# **Service Bulletin**

Bulletin No.: 21-NA-023

**Subject:** Engine Compartment Tick or Rattle Noise

5730552

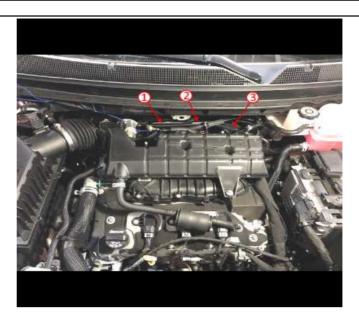
To correct this condition, verify the noise is coming from the purge tube (1) by commanding the purge solenoid on and off.

- If noise can be duplicated, then it will be necessary to install 2 rubber dampers on the tube.
- 1. Install 1 rubber damper at each location noted in the graphic above (2, 3).
- 2. Orientate insulator with seam facing down.
- 3. Secure the dampeners with a tie strap.
